Hi-Fi Products Service Bulletin

Model: TA-H3600

No. 262

Subject: Extension Cables To Facilitate Troubleshooting

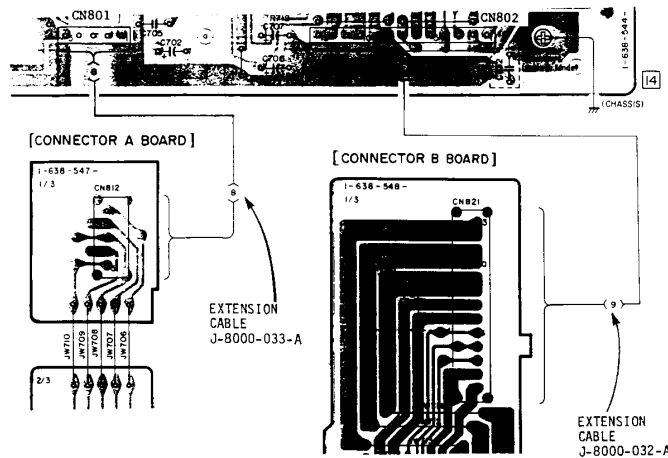
Symptom: (**)
It is impossible to troubleshoot the output circuit without extension cables.

Solution: Please order the following extension cables:

EXTENSION CABLE PART NUMBER	PURPOSE
J-8000-033-A	FOR CONNECTING POWER AMP BOARD CN801 TO CONNECTOR (A) BOARD CN812
J-8000-032-A	FOR CONNECTING POWER AMP BOARD CN802 TO CONNECTOR (B) BOARD CN821
